Alpi Pioneer Aircraft (All Types)

Inspection of Control Surface Hinge Attachment Cap-Bolts

LAA/AWA/19/23
28th November 2019
Superseding LAA/AWA/19/21

Fig 1. (Top) This sketch shows the inspection points within the empennage of all Pioneer types.

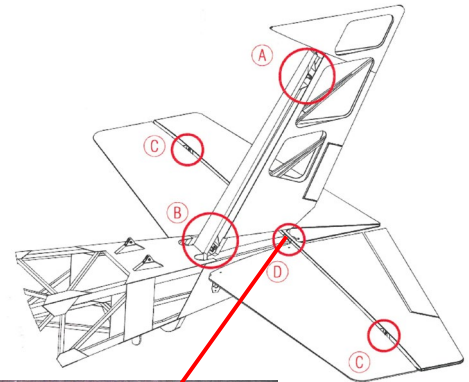
Following feedback from Pioneer aircraft owners and LAA Inspectors, LAA Engineering has reissued the AIL to allow more time before the full cap-bolt inspection and wire-locking process is completed; though the cap-bolts securing the centre elevator hinge (which support the control stop bushings) must still be inspected and wire-locked within five flying hours (or 28 days whichever occurred sooner).

LAA Engineering has issued an Airworthiness Information Leaflet requiring a repetitive inspection of the control surface hinge attachment cap-bolts for each Pioneer type operating under an LAA administered Permit to Fly.
